UNITED STATES PATENT AND TRADEMARK OFFICE

APPLICATION NO.	FILING DATE	FIRST NAMED INVENTOR	ATTORNEY DOCKET NO.	CONFIRMATION NO.
09/851,970	05/10/2001	Seiji Umemoto	Q64435	4097

Office Action Summary

DETAILED ACTION

FIG. 10

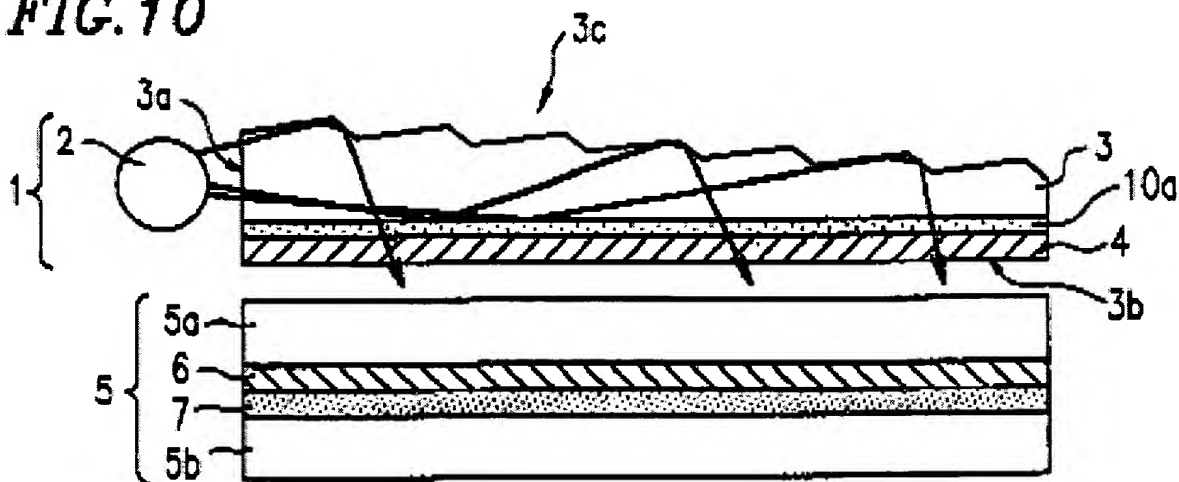
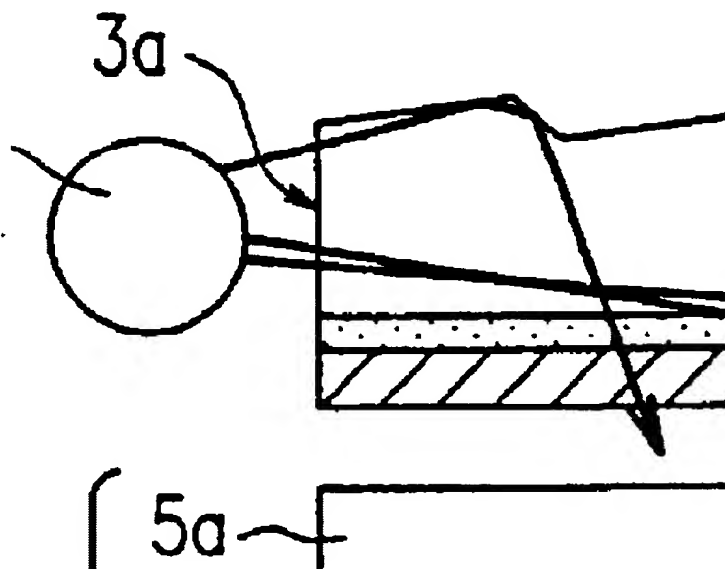
As to claims 1, 20-21, and 40-44 Masuda discloses in Embodiment 3, Figure 10, (col. 15, line 25 through col. 18, line 16) a reflection type liquid-crystal display device comprising:
a reflection type liquid-crystal display panel, 5, including a liquid-crystal cell and a reflector, 7, said liquid-crystal cell having a visual-side substrate, 5a, a back-side substrate, 5b, and a liquid crystal, 6, said visual-side substrate including a light guide, 3

(Applicant's transparent substrate), a low-refractive resin layer, 10a (Applicant's transparent layer), lower in reflective index (1.38, col. 15, lines 35-39) than the transparent substrate (1.49, col. 15, lines 35-39), and a transparent electrode (not shown), said back-side substrate having an electrode (not shown), said liquid crystal being held between said visual-side and back-side substrates so that respective electrode sides of said visual-side and back-side substrates are disposed opposite to each other, said reflector being disposed on the back-side substrate side (per Figure 10);

at least one illuminator, 2, disposed on one of side surfaces of said reflection type liquid-crystal display panel and entirely below the optical path control layer having a repetitive structure of optical path changing slopes, 3c, on an outer side of said visual-side substrate and being higher in refractive index (1.49, col. 15, lines 35-39) than said low-refractive-index transparent layer, each of said optical path changing slopes being

inclined at an inclination angle in a range of from 35 to 48 degrees with respect to a reference plane of said visual-side substrate as graphically illustrated by the light path arrow in the upper portion of Figure 10 below.

Masuda does not explicitly teach in the text that his angle of slopes illustrated in Figure 10 are within the range of 35 to 48 degrees.

(1) It is respectfully pointed out that drawings that are not to scale are generally of little value when making determinations as to dimensions. However, they tend to be quite reliable for ray traces, because the drawing must convey the path of the ray. The

drawing of Masuda clearly indicates a ray path that makes a turn of about 90° which would be achieved with slopes inclined $35-48^\circ$ (a practice well known in the art at the time the claimed invention was made). Furthermore, Masuda clearly teaches the angle as a results effective variable, optimization of which takes only ordinary skill in the art of liquid crystals (MPEP 2144.05). However, Egawa is applied as further proof that the use of slopes inclined $35-48^\circ$ was well know in the art at the time the claimed invention was made, with proper motivation to combine.

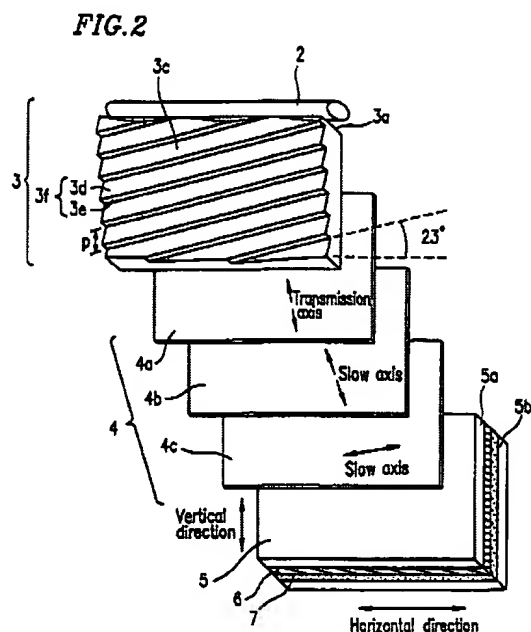
Egawa teaches the use of [col. 8, lines 28-33] angle of slope (alpha) in the range of 46 to 52 degrees from vertical [equates to 38 to 44 degrees from Applicant's reference plane of the visual side substrate which overlaps Applicant's claimed range of 35 to 48 degrees] to improve contrast and eliminate unwanted moiré pattern for improved display performance [Abstract].

Egawa is evidence that ordinary workers in the art of liquid crystals would find the reason, suggestion, or motivation to add an angle of slope of 38 to 44 degrees to improve contrast and eliminate unwanted moiré pattern for improved display performance.

**FIG. 10A**

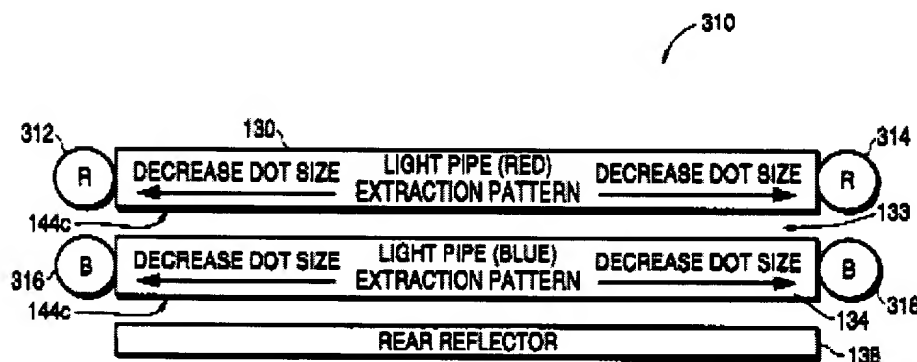
Evanicky teaches the use of illuminators disposed on at least two of the side surfaces to provide greater brightness [col. 16, lines 37-46].

Evanicky is evidence that ordinary workers in the art of liquid crystals would find the reason, suggestion, or motivation to add illuminators disposed on at least two of the side surfaces to provide greater brightness.

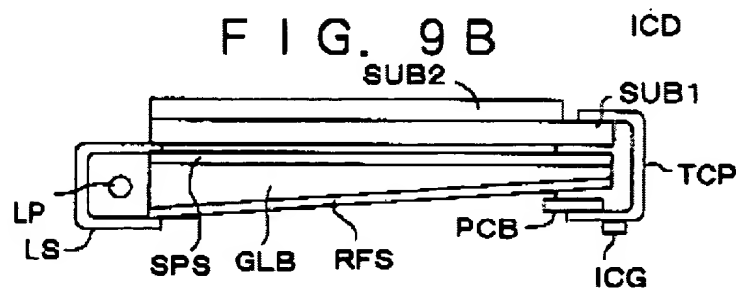
Yano teaches the use of transparent glue (Applicant's tacky adhesive layer) having a refractive index of 1.40-1.55 which would result in the refractive index of said adhesive layer being higher by at least $(1.40-1.38) = 0.12$ (Applicant's 0.05 or more) than that of said low-refractive-index transparent layer to provide a bright display with only low-power light [0053].

Yano is evidence that ordinary workers in the art of liquid crystals would find the reason, suggestion, or motivation to use a device wherein said optical path control layer is made of a transparent sheet, and is bonded to said liquid-crystal display panel through an adhesive layer having a refractive index higher than that of said low refractive index transparent layer, wherein said adhesive layer is constituted by a tacky layer, and wherein each of the refractive index of said optical path control layer and the refractive index of said adhesive layer is higher by 0.05 or more than that of said low-refractive-index transparent layer to provide a bright display with only low-power light.
